SCS-VR™ Virtual Receiver Software

Software Update

Effective February 7, 2018, SCS-VR Virtual Receiver software is being manufactured as Version 1.4.1 (2/6/18) and contains the following features and improvements.

Figure 1: New Valid Traps Tab

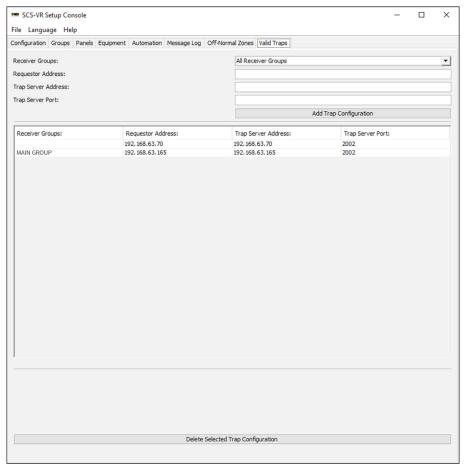
You now have more control over which IP addresses and ports can be used for sending traps. On the **SCS-VR Setup Console** screen, navigate to the **Valid Traps** tab and configure which IP addresses and ports can be used for traps. See Figure 1. If no configuration is entered, SCS-VR uses the default restrictions.

Figure 2: New Options in the Configuration Tab

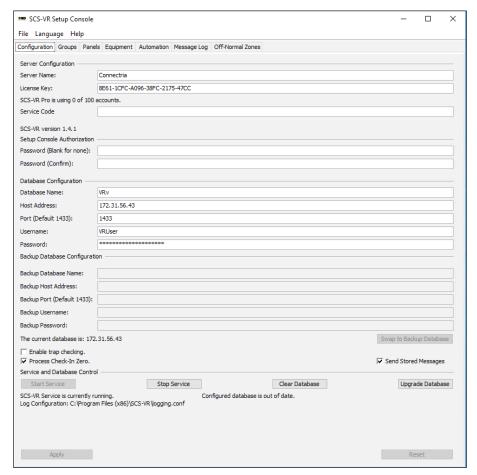
To enable this feature in SCS-VR, navigate to the **Configuration** tab on the **SCS-VR Setup Console** screen and check the **Send Stored Messages** option. See Figure 2.

To enable this feature in SCS-VR, navigate to the **Configuration** tab on the **SCS-VR Setup Console** screen and check the **Process Check-In Zero** option. See Figure 2.
